RE: FINISHED FLOOR REQUIREMENTS FOR (L23/D13)

DRAINAGE INFORMATION SHEET

PROJECT TITLE: SINGLE FAMILY D.V. ZONE ATLAS/DRNG. FILE #: 2-23/D13

LEGAL DESCRIPTION: Lot 7, Block 15, Wells Sandia ManorCITY ADDRESS: 201 LAWRENCE DRIVE NE

LOT 7 Block 15
 WELL'S SANDIA MANOR (CI-26)
 Albuquerque, Bernalillo County, New Mexico
 Feb. 2, 1990
 Topographic Information

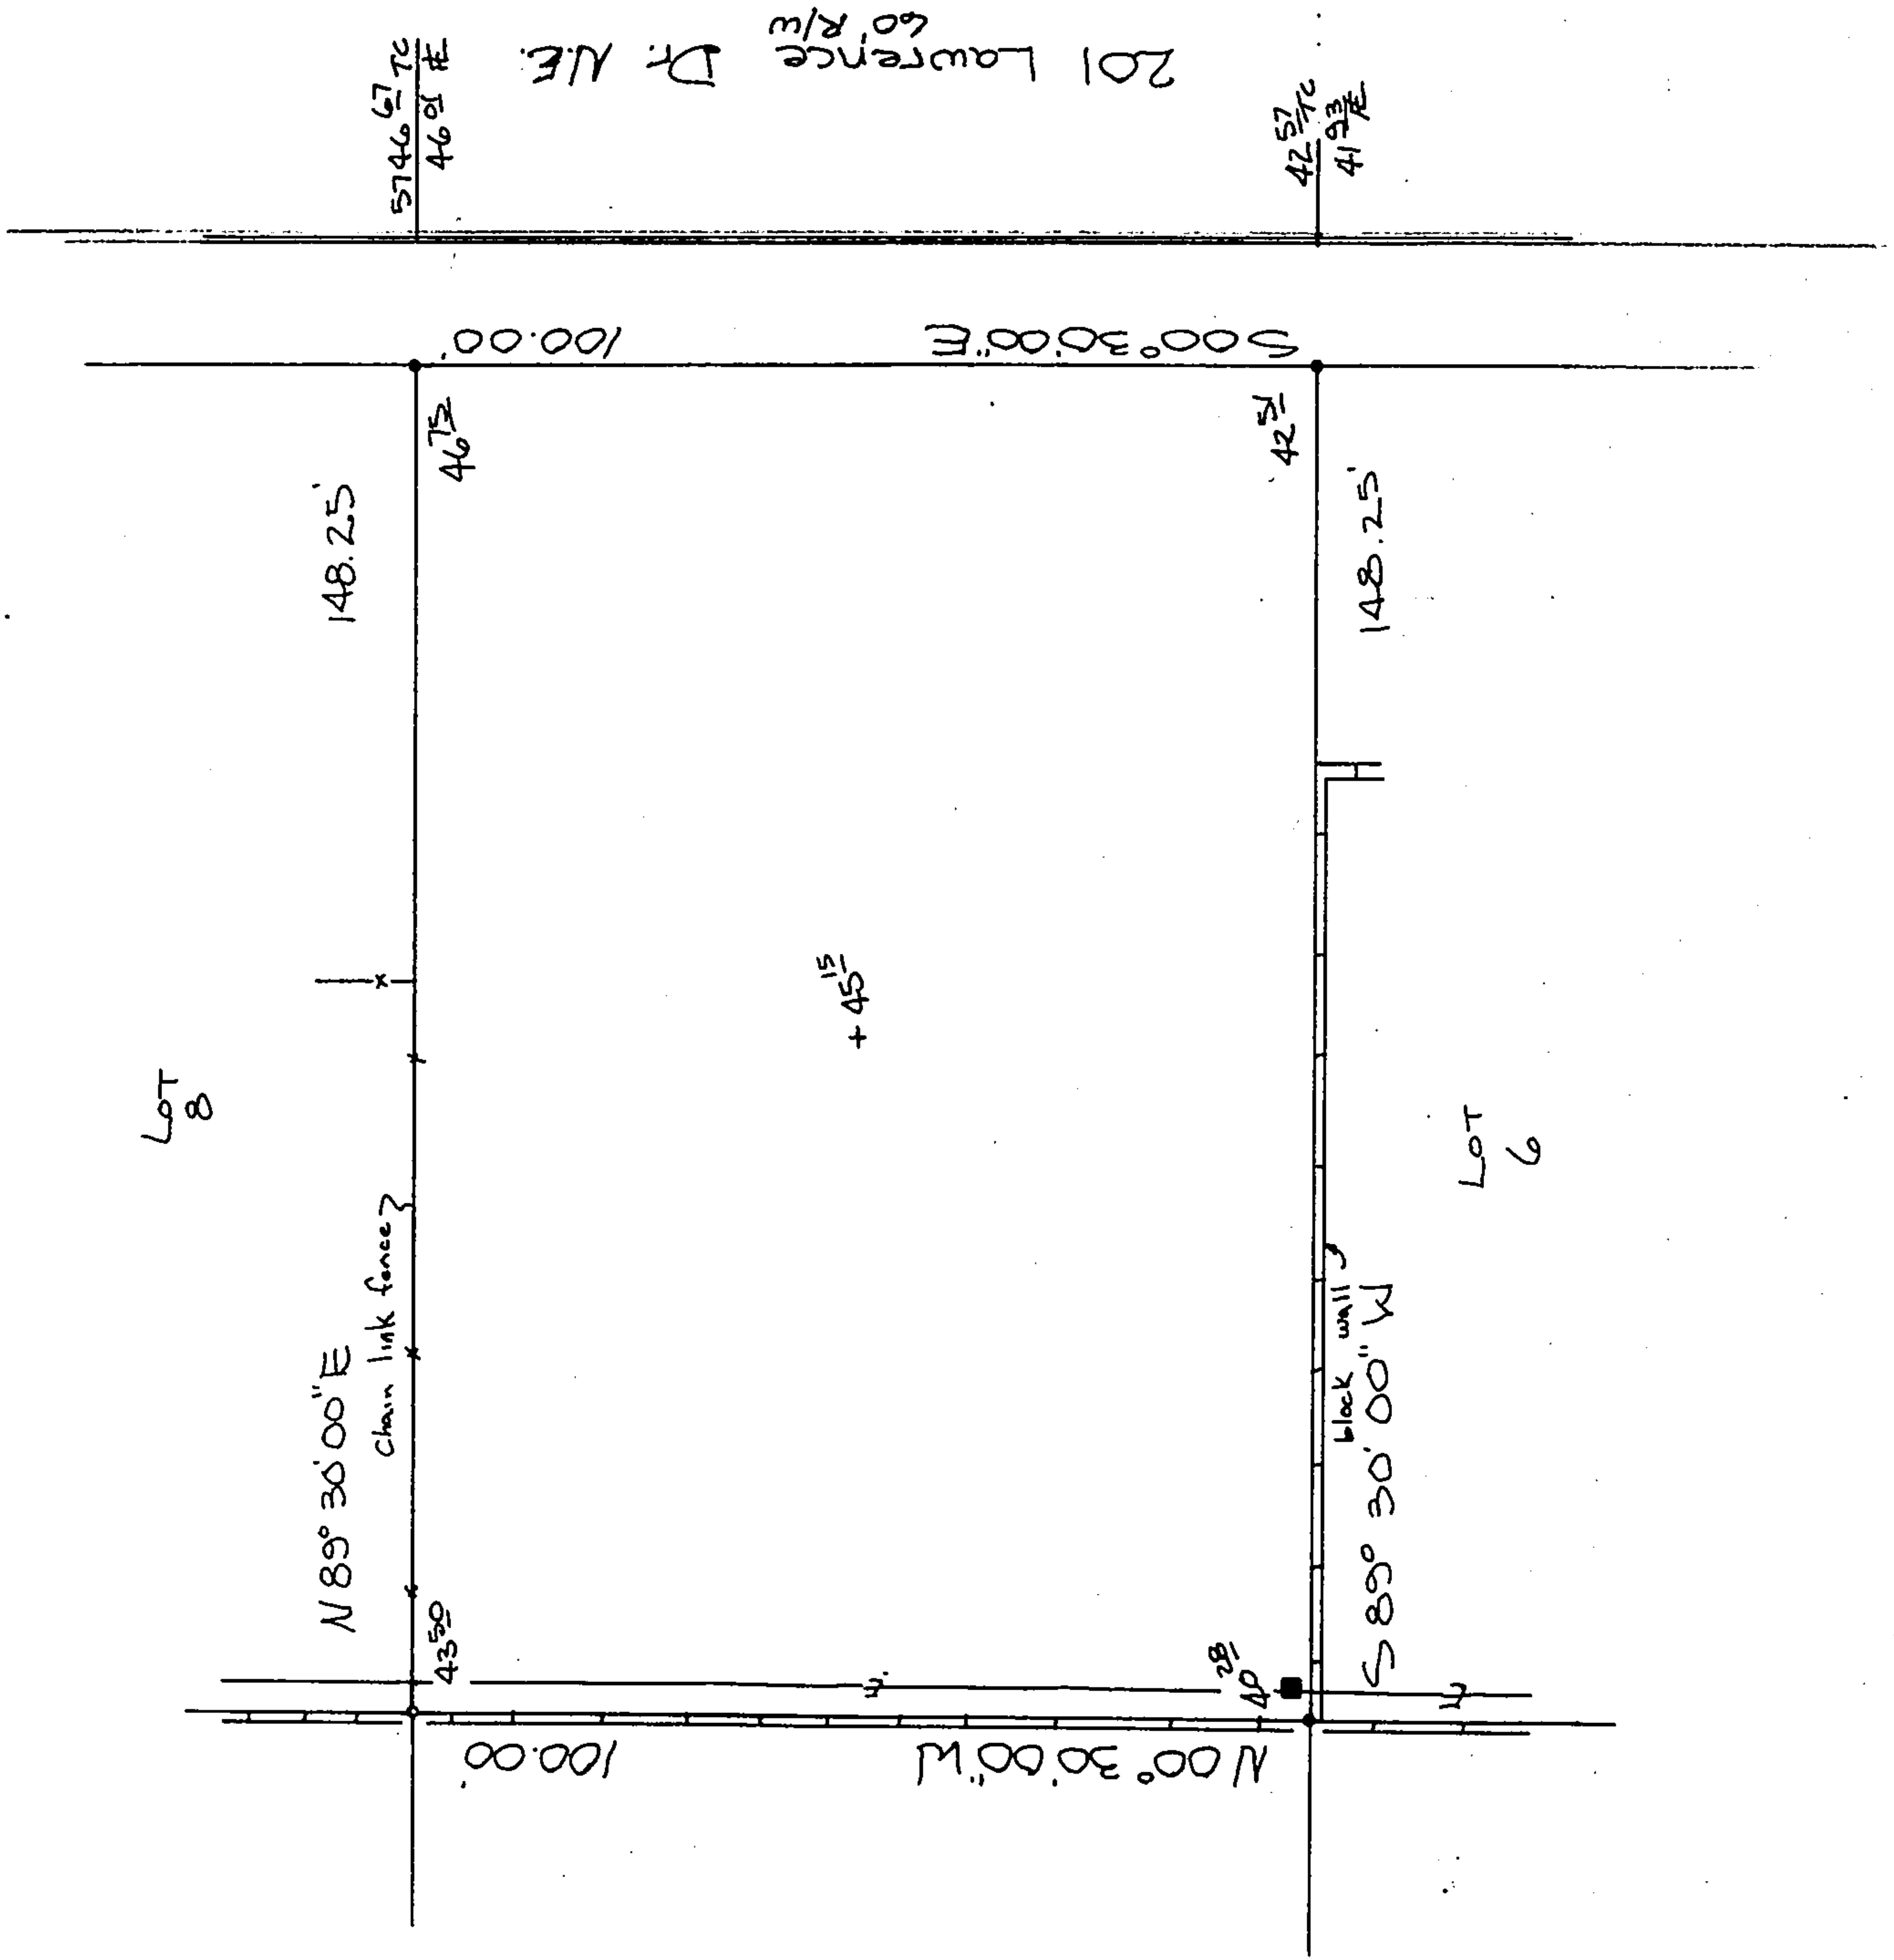
The purpose of this letter is to address your request for a variance to the finished floor requirement per the Floodplain Ordinance for Lot 7, Block 15, Wells Sandia Manor. My understanding of your request is because the finished floor would be 6 feet above the existing grade at the rear yard, or the requirements of importing additional fill material.

The Floodplain Map Panel 350002-0037 effective October 1983, identifies a floodplain of A0 (1') on the street adjacent to your property, this is the reason you were required to elevate your finished floor above this floodplain. After further investigation it was determined a storm drain system was built in 1985 upstream from your property. It is possible that this storm drain system may have removed the floodplain on this street. The Federal Emergency Management Agency may be in the process of updating these floodplain maps by October of 1990. Once FEMA accepts this storm drain system and revises the map, then the floodplain would become officially deleted.

I met with property owner today (Alex Hendrin) because he had problems with his initial proposed Finished Floor GRADE. I granted him a variance that he could prorate the required Finish Floor by using the building setback distance from the North Property Line, to ~~est~~ calculate his Finish Floor Elevation, from the difference in elevations of curb at NE and SE corner, ~~require~~ require to be 2' above gutter.

Since there are existing upstream storm drain improvements, the finished floor elevation may be established one foot (1') above the gutter, at the center of the building pad. Please be advised that a Land Surveyors Certification will be required once the finished floor is constructed.
